ADDENDUM NO. 02

November 14, 2025

To Drawings and Specifications dated October 24, 2025

Reynolds Elementary School Maintenance Improvements
Spring Independent School District

1/4" = 1'-0"

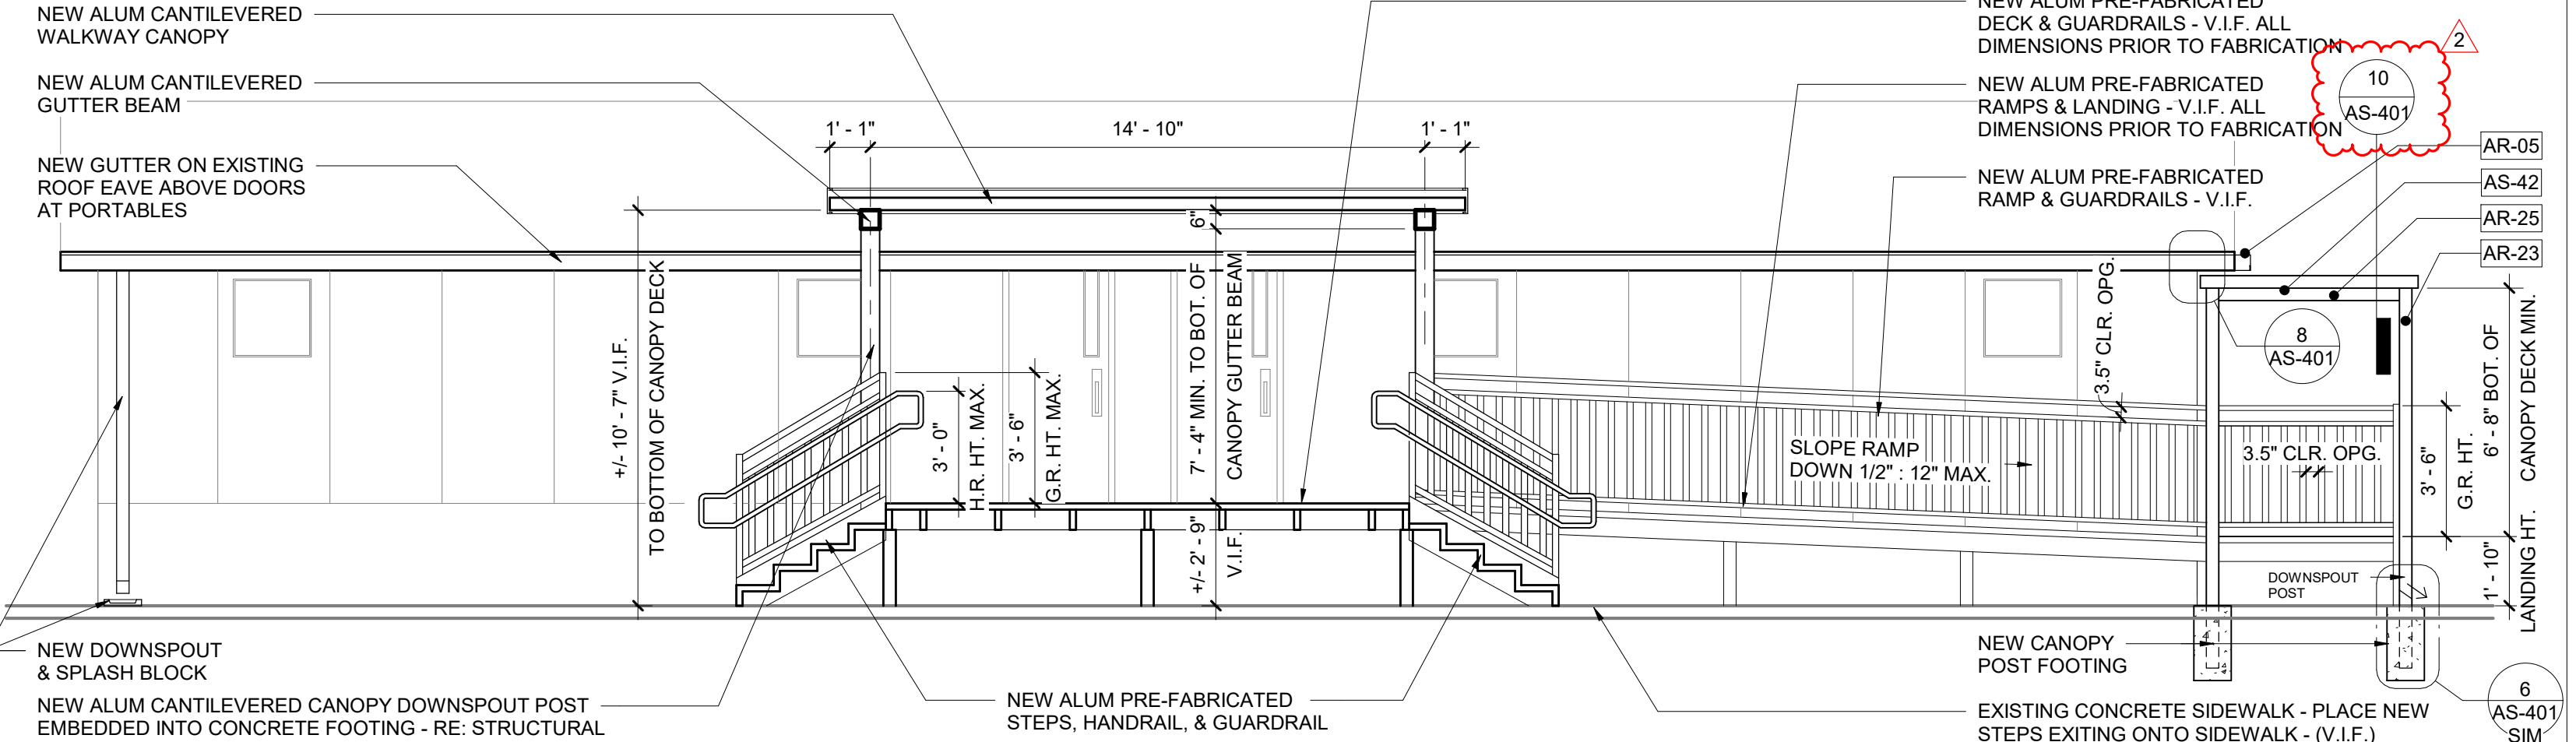
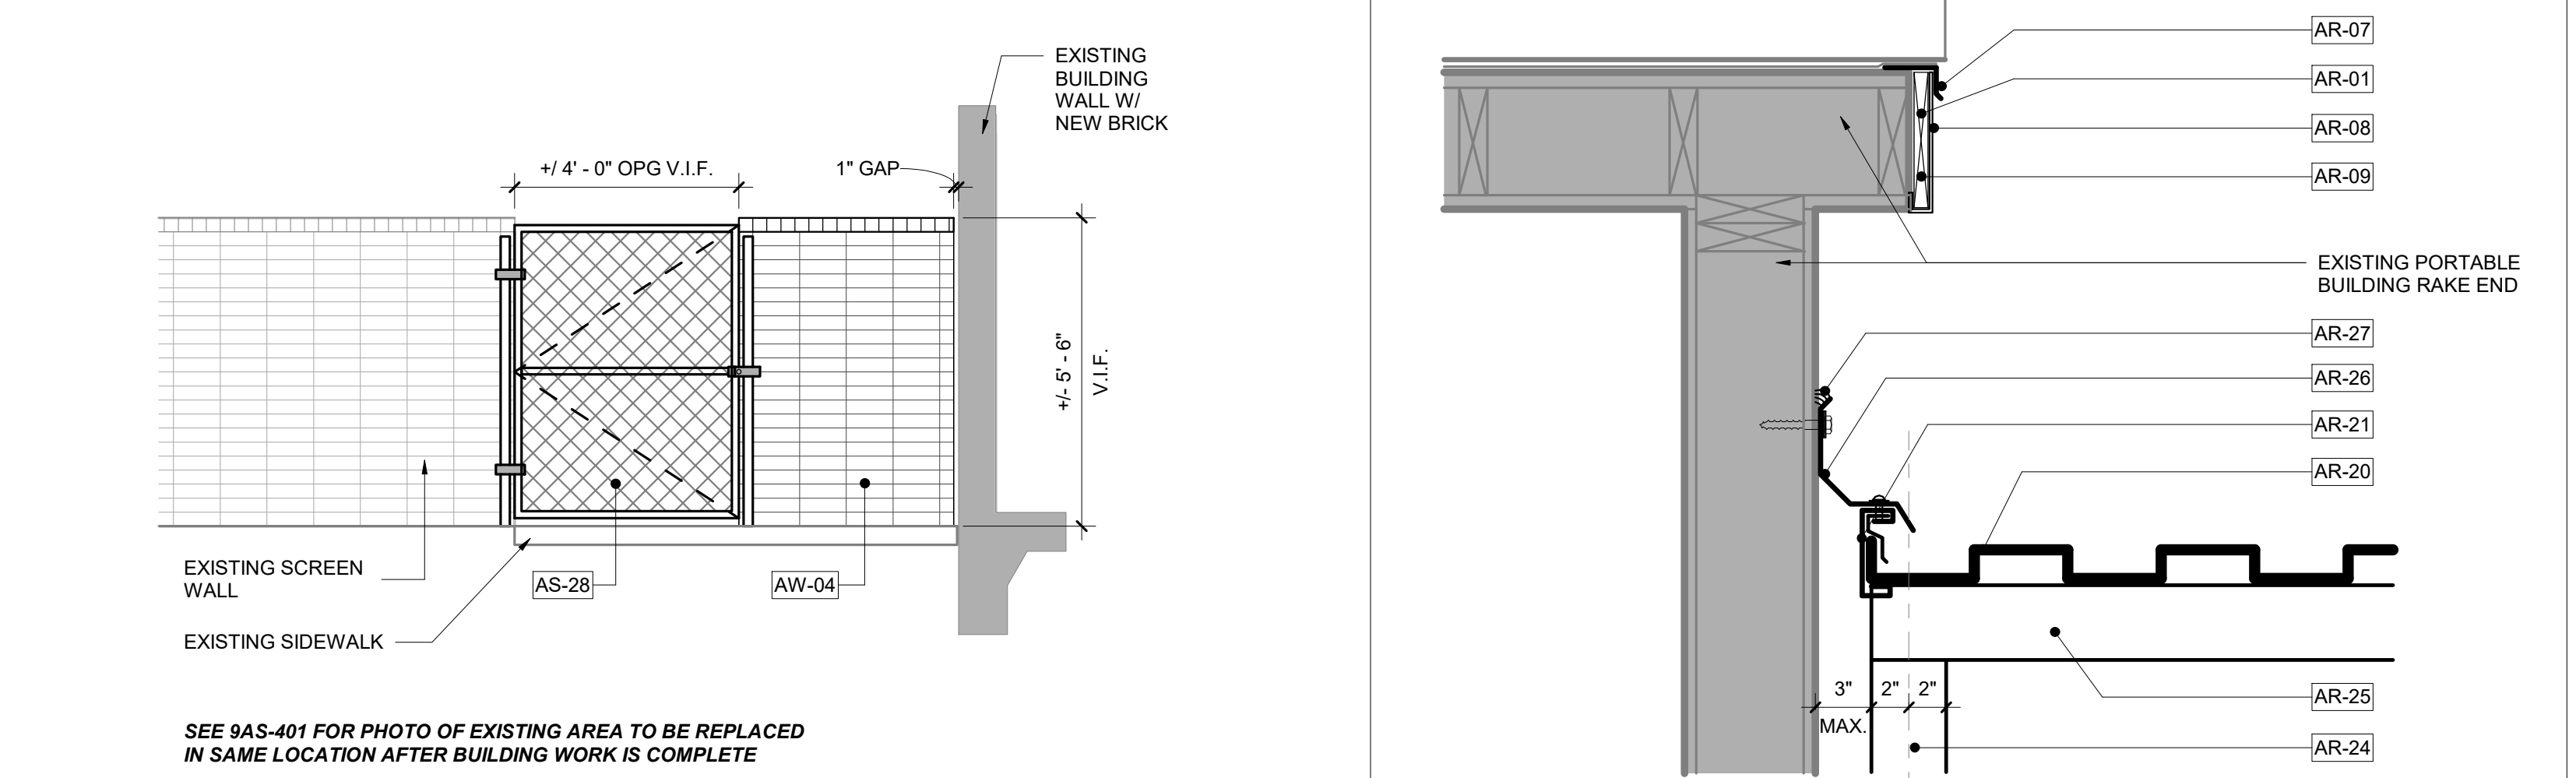
- Item No. 9 Sheet AS-401, Enlarged Portable Plan
 A. Discard and replace with enclosed.
 B. Add references to new detail 10.
- Item No. 10 Sheet A-502, Elevations, Sections and Details – Exterior wall

ROOF PLAN

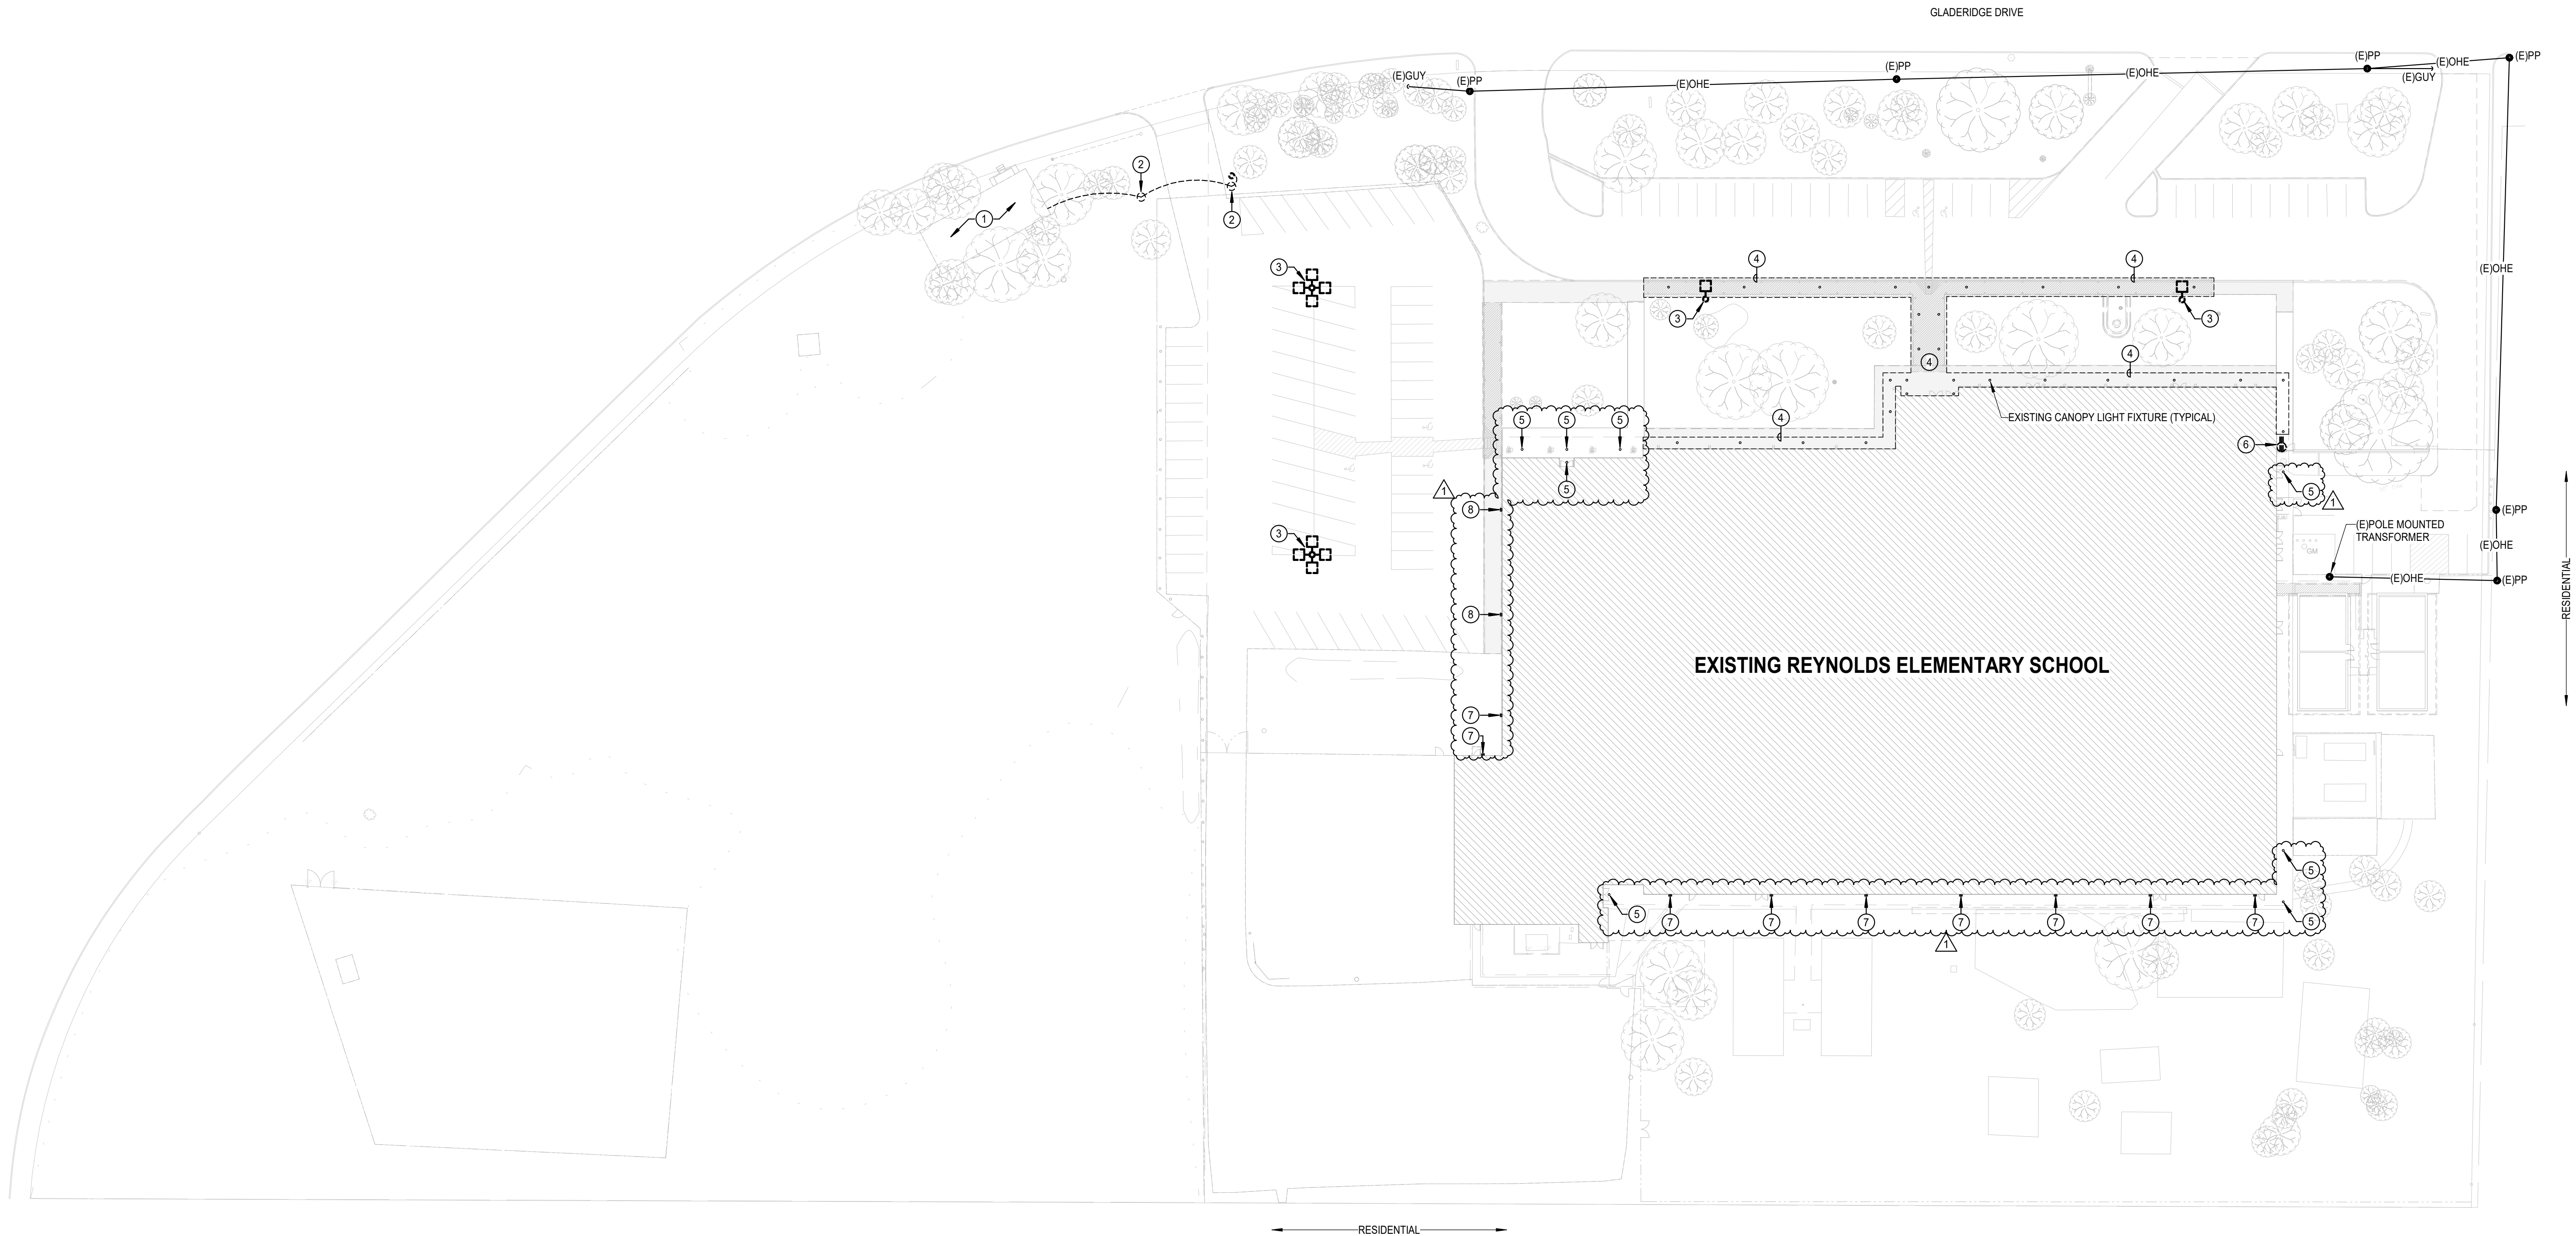
- Item No. 11 Sheet A-504, Elevations, Sections and Details – Canopy
 A. Discard and replace with enclosed.
 B. Add references to new detail 3.
- Item No. 12 Sheet A-701, Roof Plan

A. Discard and replace with enclosed.
 B. Add references to new details 2, 3 and 4.
- Item No. 13 Sheet A-702, Manufacturer Roof Details
 A. Add the following general note:
 Manufacturer’s details provided are for membrane installation requirements. Refer to specifications for removal of existing materials, coverboard, substrate and other requirement for complete re-roofing work.

**ELECTRICAL
DEMOLITION SITE
PLAN**

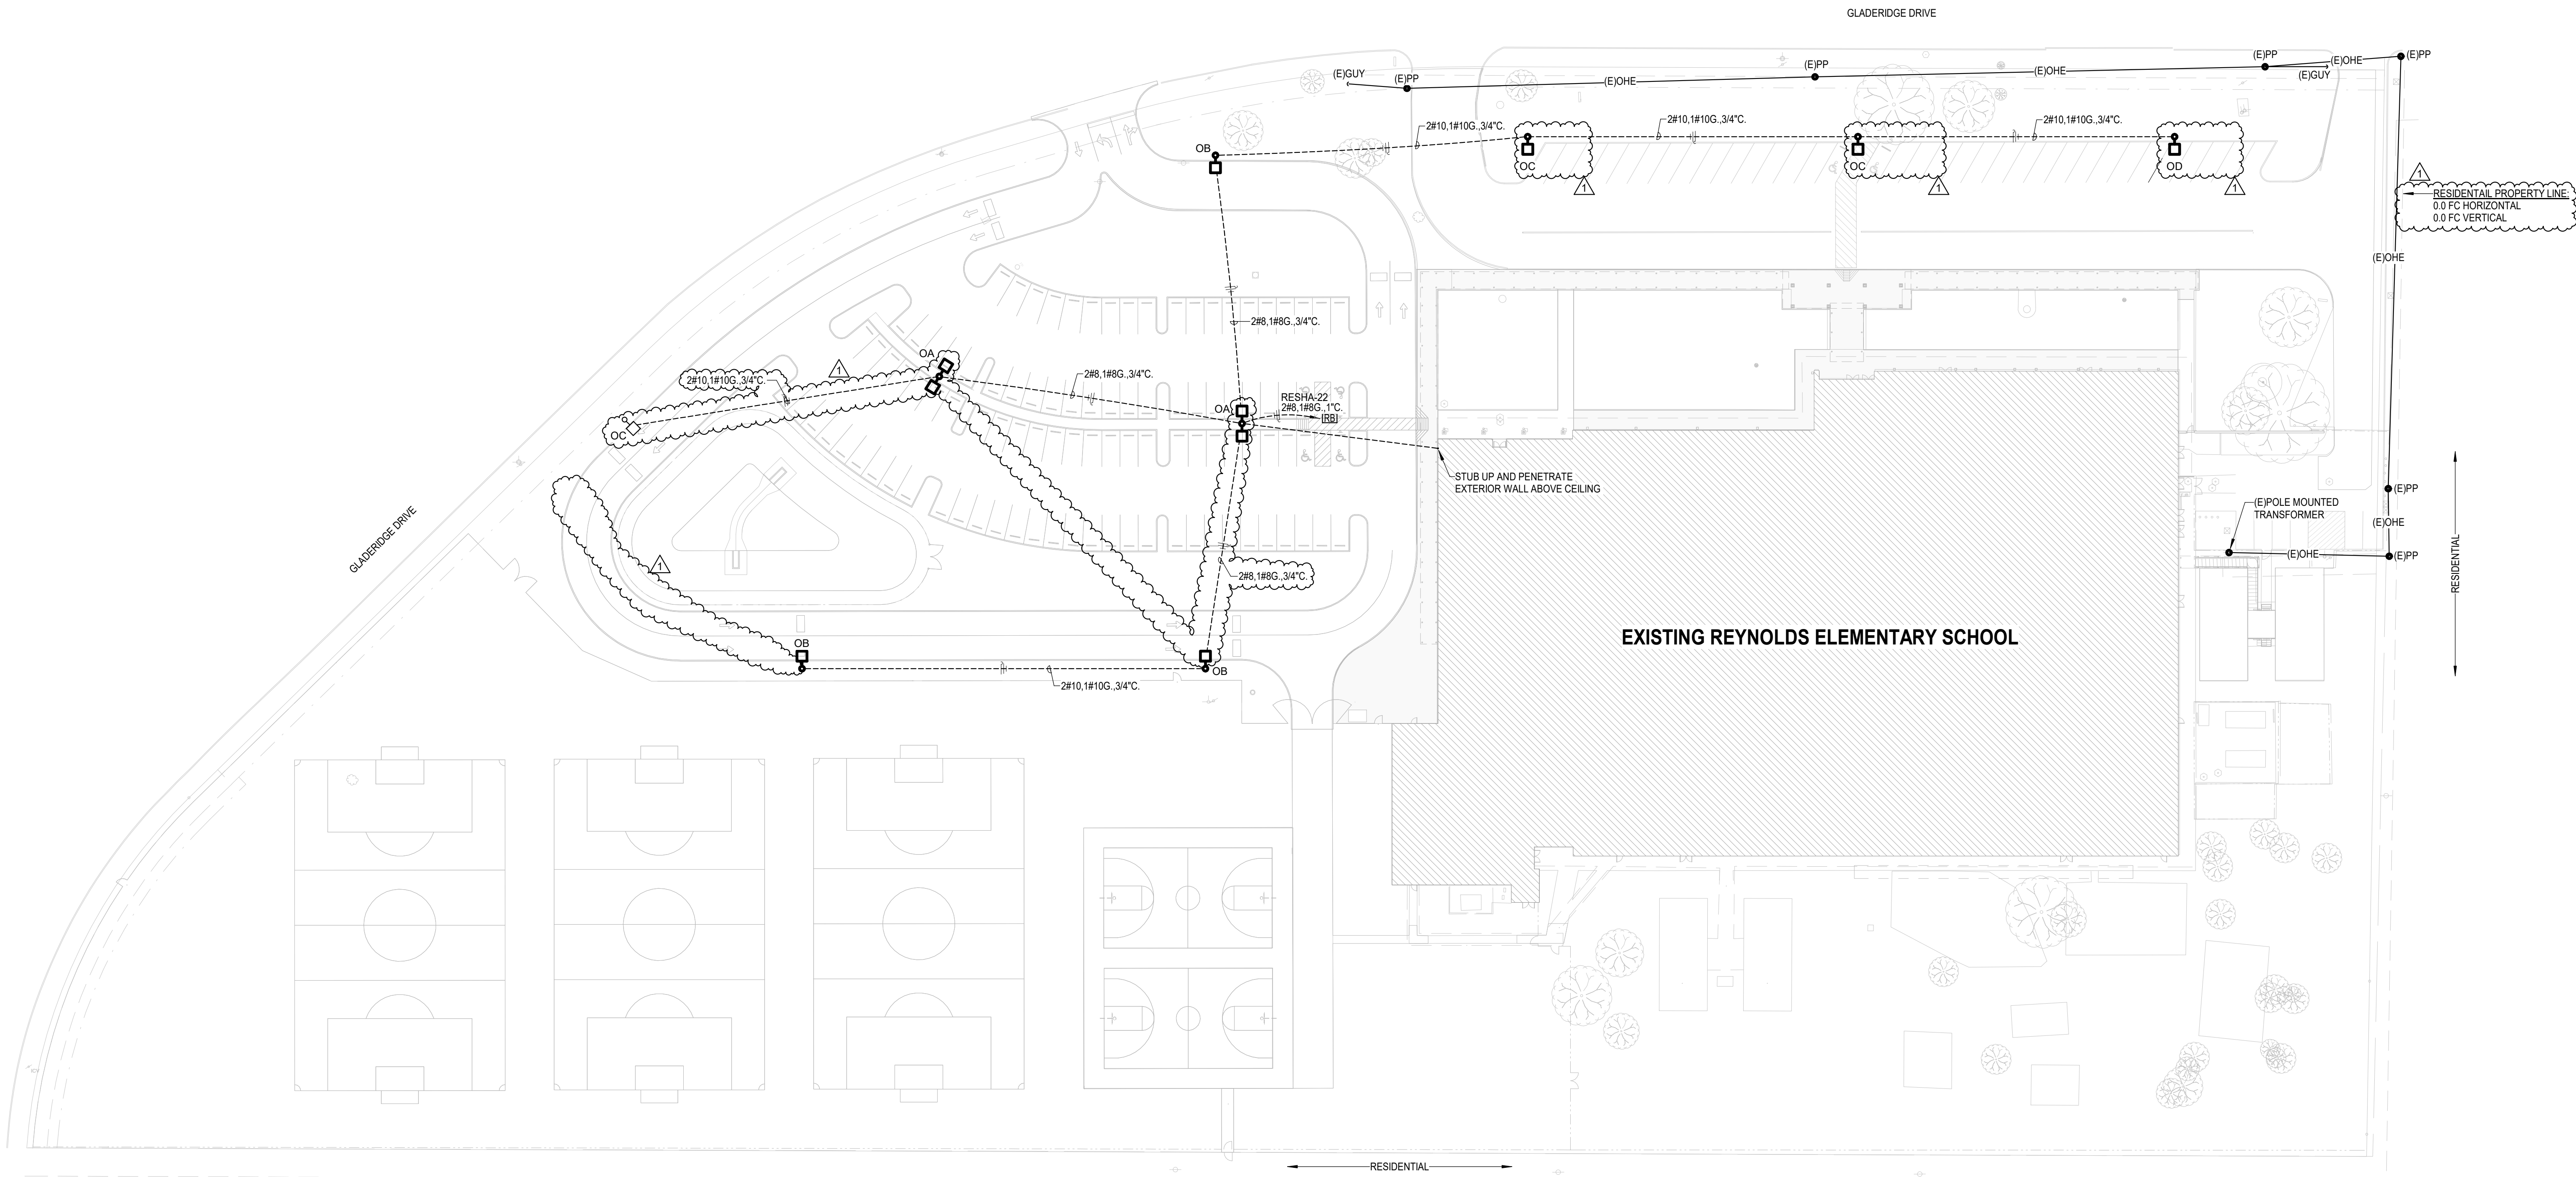
- Item No. 15 Sheet E0.01, Electrical Demolition Site Plan
 a. Discard and replace sheet in its entirety.
 b. Revise keyed note #3, Note shall read: “...8” BELOW FINISHED GRADE, REMOVE CONDUCTORS BACK TO SOURCE.”

c. Add keyed note #8, note shall read: “DISCONNECT AND REMOVE EXISTING WALL MOUNTED LIGHTING AND ASSOCIATED CONDUIT/WIRE BACK TO NEAREST ACTIVE JUNCTION BOX. CONTINUITY OF EXISTING CIRCUITRY TO REMAIN. PROVIDE BLANK STAINLESS STEEL COVERPLATE FOR EXISTING OUTLET BOX.”

d. Revise exterior canopy light fixture demolition, typical of 8.
 e. Revise exterior wall mounted light fixture demolition, typical of 11.
- Item No. 16 Sheet E0.02, Electrical Site Plan
